**Re: BOWDENS SILVER PROJECT (WATER SUPPLY AMENDMENT REPORT) - APPLICATION NUMBER SSD-5765**

Attached is the Objection by Lue Action Group (**LAG**) to the Amendment as lodged by Bowden's Silver Project (Bowdens) to *State Significant Development [SSD] – 5765* detailed within the Amendment Report for the Bowdens Silver Project (R.W. Corkery & Co. Pty.Limited, March 2022).

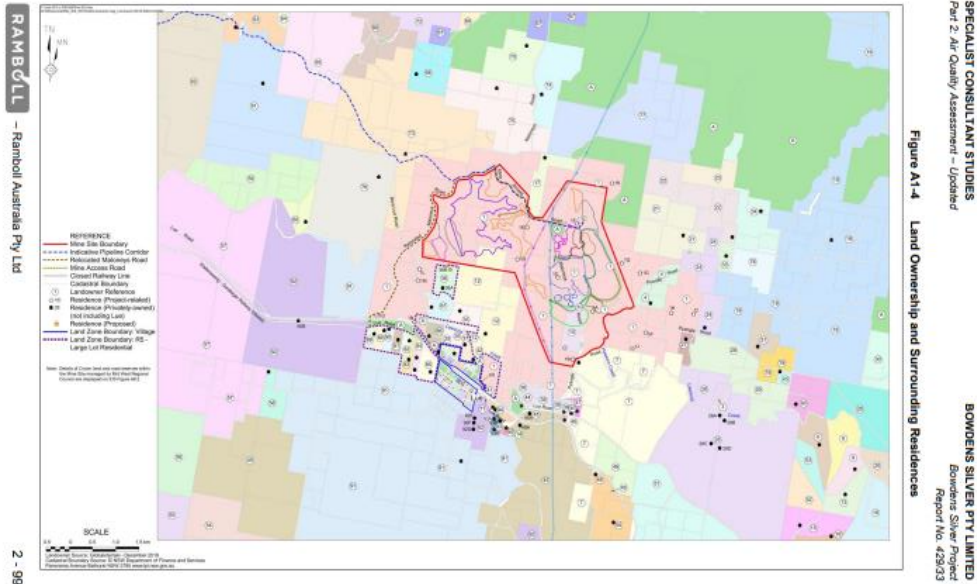
LAG engaged Engeny to verify concerns and quantify Visual Impacts from the realignment of the 500kV transmission line as presented in the first amendment (RTS). As a result of Engeny's report and numerous submissions expressing concerns about the relocation of the Transmission Line Bowdens has relocated the Transmission Line 200m to the east and closer to the existing Transmission Line. LAG has not engaged Engeny to verify concerns and quantify Visual Impacts from the amended relocation of the Transmission Line because such minor changes to the proposal to relocate this major component do not require an additional report. Richard Lamb and Associates (Mr Lamb) was engaged by Bowdens to carry out an updated visual impact assessment and as he has only indicated that 3 homes will have a reduced impact this is not a significant reduction in the visual impacts experienced by Lue. LAG invites Mr Lamb to conduct a Visual Impact Assessment from every house in Lue rather than a select few that he has predetermined will have little or no view of the mine site. LAG believes that it is not unreasonable to request that Bowdens instruct Mr Lamb to specifically assess the impacts from all properties from the Havilah Gap to Monivae Hill including Property 94 and Property 83, both of which will have their views substantially diminished. Mr Lamb clearly has a very limited scope but he should not exclude properties that will obviously have their views substantially changed. Bowdens stated that it was not reasonable to expect them to conduct an assessment from properties to the east of the proposed development. LAG is of the opinion that it is not unreasonable to require Mr Lamb to assess the visual impact to homes and properties in Lue that are located to the east of the village and closer to the mine site than the village. LAG believes that it is reasonable for Bowdens to engage Mr Lamb to assess the Visual Impacts to all neighbouring properties as well as those properties that clearly will have a view of the mine site and its components including the Waste Rock Embankment, the Tailings Storage Facility and the Transmission Line. In particular Properties 76, 57, 59, 61 and 91 and all properties with a view of any Bowdens component. Most recently changes to the new Maloneys Road creek and railway crossings may require visual assessment from properties 81 to 93. There has been no visual assessment from any point on property 92 or Property 91 or Property 94. The visual assessment from property 83 carefully ignored the eastern view over the mine site while at the same time stated that the resident would only be visually impacted for 9 years. Clearly an oversight. The property map LAG refers to can be found at Part 2: Air Quality Assessment – Updated Report No. 429/33 2 - 100 – Ramboll Australia Pty Ltd Figure A1-5 Land Ownership (Lue) page 2-102. Unfortunately the property numbers are unreadable in its copied form below.
